Interim Staff Position on Environmental Qualification of Safety-Related Electrical Equipment

Including Staff Responses to Public Comments

Resolution of Generic Technical Activity A-24

U.S. Nuclear Regulatory
Commission

Figure C-1. Qualification Profiles for BWR and Ice Condenser Containments

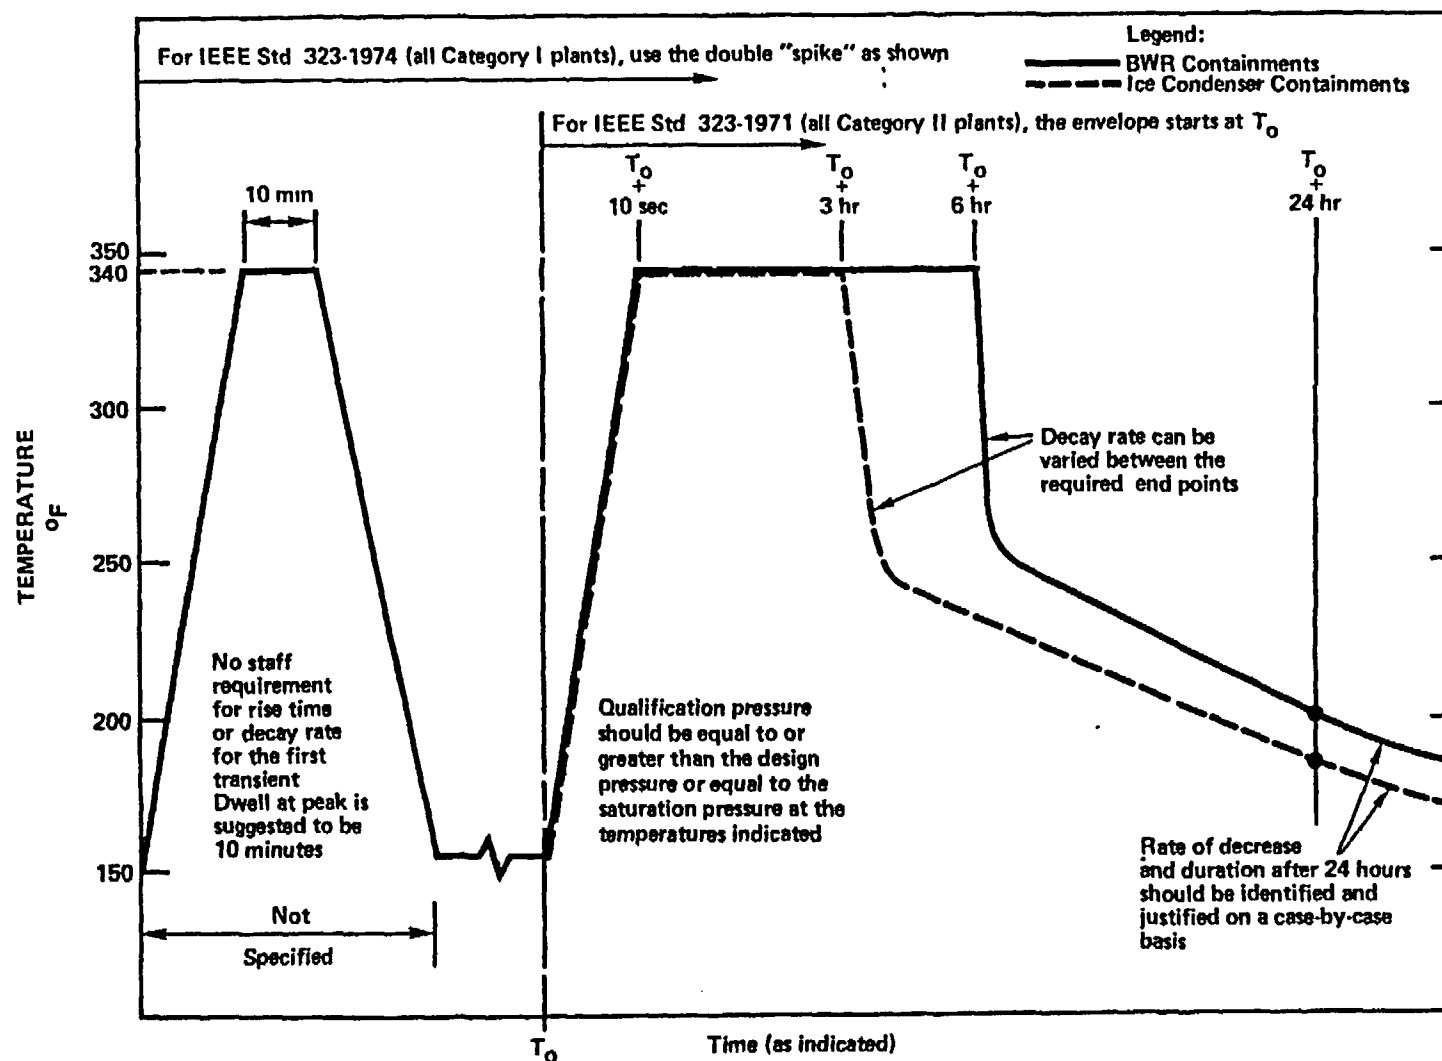
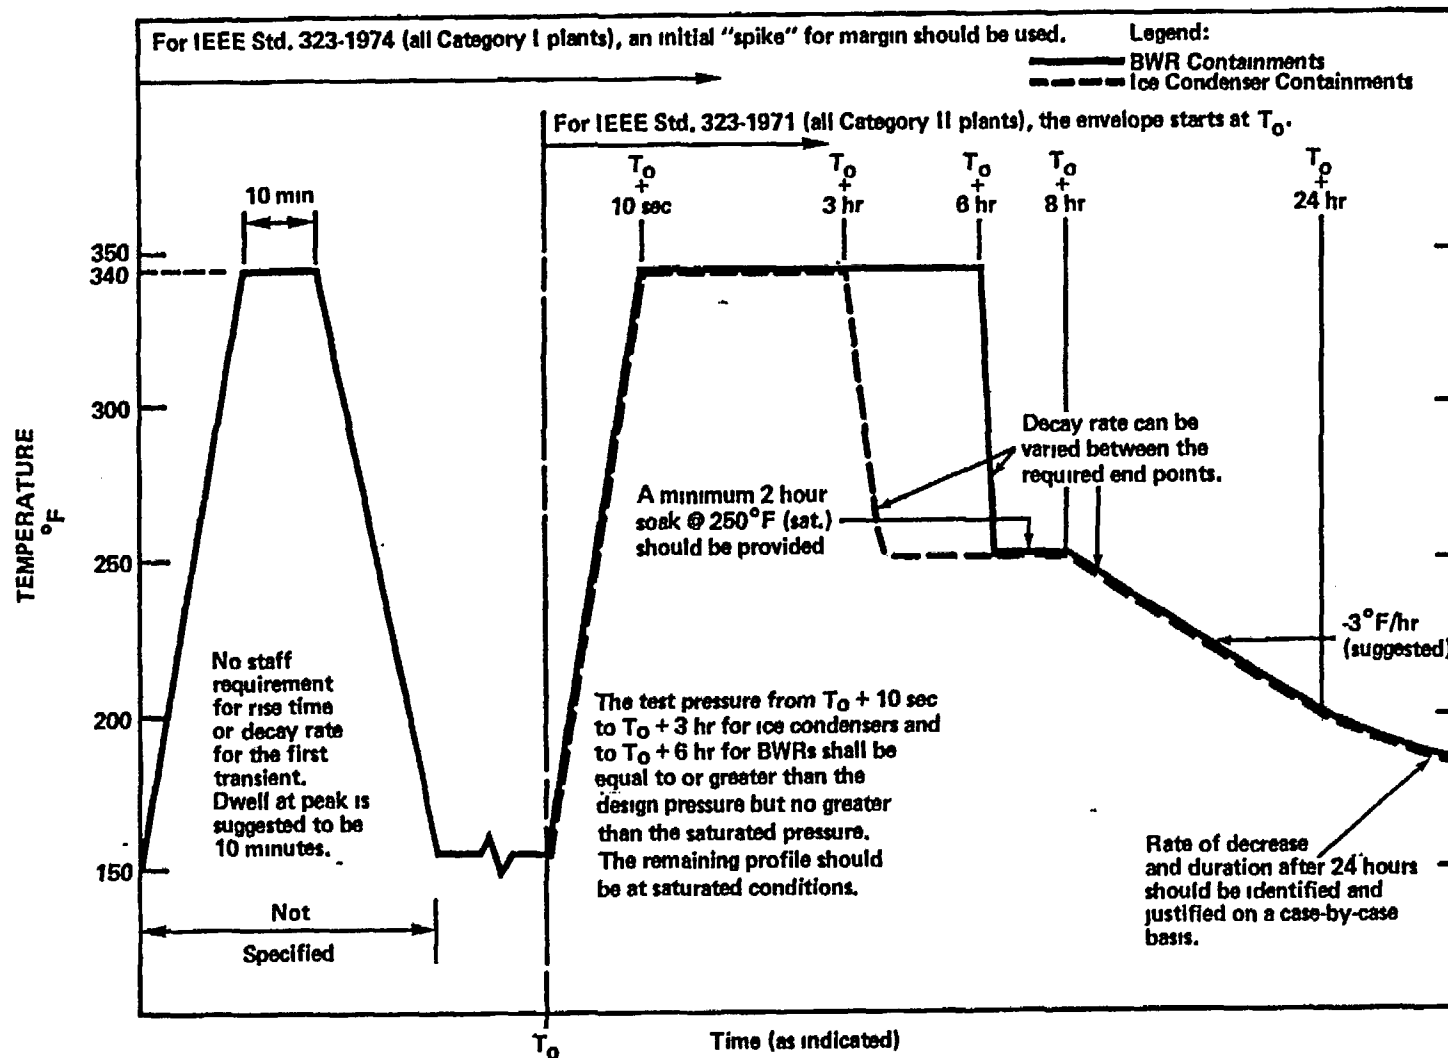
COMMENT NO. 97A: We feel and have felt that there is inherent danger
(Appendix C) in publishing a "universal" environmental profile for use by all in qualifying equipment (Figure C-1). This is the reason IEEE 323-1974 listed numeric values as "typical" and to be used with caution. We recommend the same here.

COMMENT NO. 97B: Delete note on use of "double spike" (Figure C-1) based
on our general comments on Section 3. Also, we feel and have felt that there is inherent danger in publishing a "universal" environmental profile for use by all in qualifying equipment. This is the reason IEEE 323-1974 listed numeric values as "typical" and to be used with caution. We recommend the same here.

One should recognize that the curve in Figure C-1 is provided for those BWR and PWR ice condenser facilities which do not have plant-specific accident profiles available for use in their specific equipment-qualification program. It would be possible for a utility/applicant to provide, on a case-by-case basis, documentation which yields a plant-unique curve. Should a plant owner want to upgrade a currently installed spray system, it may be possible to shorten the time for the superheat qualification test by providing adequate justification that the spray system will indeed actuate and serve to mitigate the accident, thereby yielding a substantially lower environmental profile. Because Sections 1.1(3) and 1.2(3) clearly allow the use of the plant-specific profiles, no modification was proposed as a result of these comments. (See also staff response to Comment No. 57 regarding the use of a "double spike.")
